August 1, 2009

Texas Instruments strives to provide the highest quality products for our customers and to remain in compliance with our strict quality standards. This is a notification of a product issue.

XTR110KP XTR110KU XTR110KU/1K XTR110AG XTR110BG

Example of  $V_{REF}$  pin connections that allow the device to operate correctly.

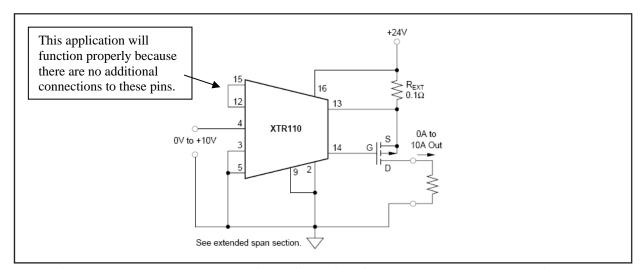
The device may not function properly if the reference voltage pins, pin 15 ( $V_{REF}$  and pin 12 ( $V_{REF}$  sense), are connected to any additional circuitry.

The device +10V voltage reference will function properly under all conditions if the reference voltage pins, pin 15 ( $V_{REF\ FORCE}$ ) and pin 12 ( $V_{REF\ SENSE}$ ), are connected to each other, but not connected to any additional circuitry.

If pin 15 ( $V_{REF\ FORCE}$ ) and pin 12 ( $V_{REF\ SENSE}$ ) are connected to external circuitry a percentage of units may fail to start up properly when power is first applied. A

larger percentage of units may fail to start properly at low temperature. If a device starts up properly, it will continue to operate properly while power is applied.
